**Addendum x to
ASHRAE Guideline 36-2018**

Proposed Addendum x to Guideline 36-2018, High-Performance Sequences of Operation for HVAC Systems

Second Public Review (April 2021)

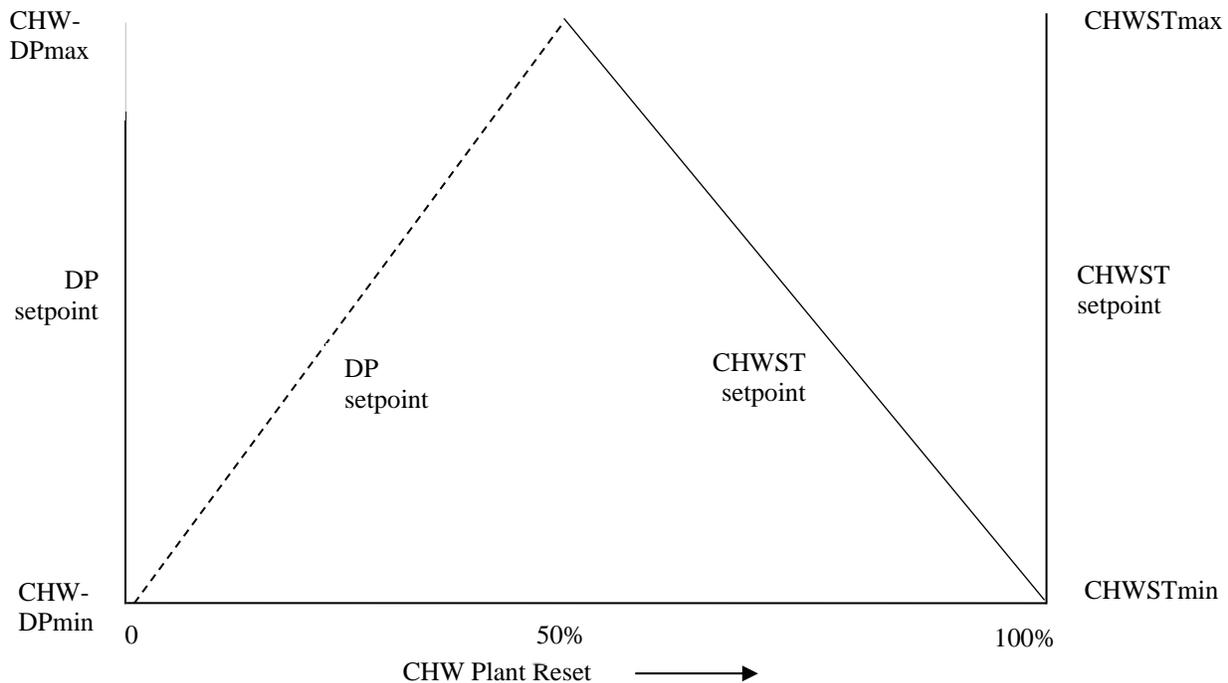
Add following to Section 5.20.4.15 to clarify when these two paragraphs apply:

Retain the following clause for primary-secondary chiller plants with CHW isolation valves where the primary loop does not have a single CHWST sensor that measures the combined supply flow of all chillers. See schematics in Informative Appendix A for examples. Delete otherwise.

e. Where a primary CHW supply temperature sensor is not provided, primary CHW supply temperature used in staging logic shall be the weighted average supply temperature of all chillers with open CHW isolation valves. Temperatures shall be weighted by design chiller flowrates.
